Response to NRC Concerns on TSTF-360

July 12, 2006 Meeting

Bottle Analogy

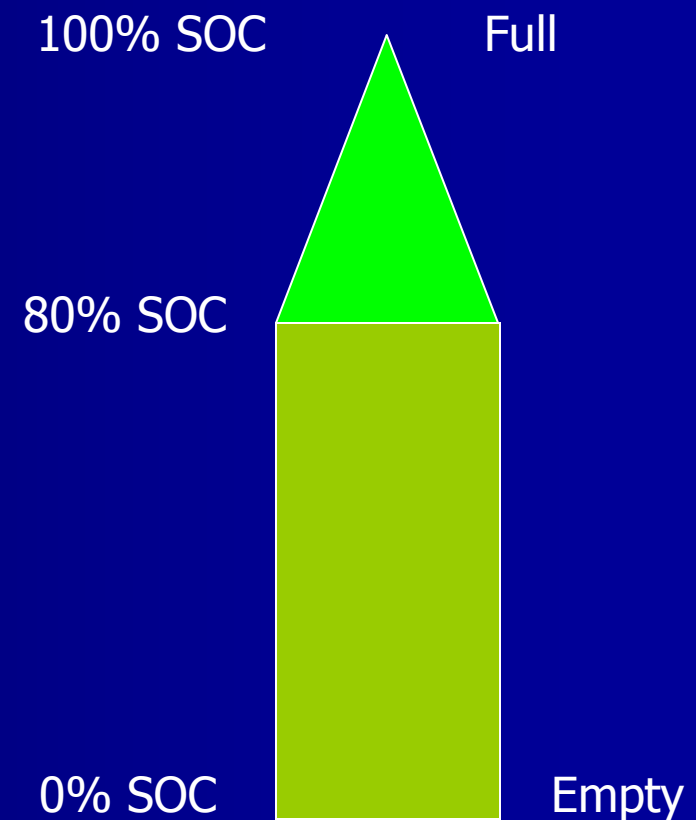
- Float current may or may not accurately indicate State of Charge (SOC) routinely?
 - Due to variation in voltage and cell resistance shown in the Equation: $I = (E - E_b)/R$
 - Uncertainty during steady-state?
- Recommend using SG for routine SR's and float current after discharges

- When no sulfate ions remain to be converted, the battery is fully charged!
- Exponential curve defines charge remaining.
- Full = Float only
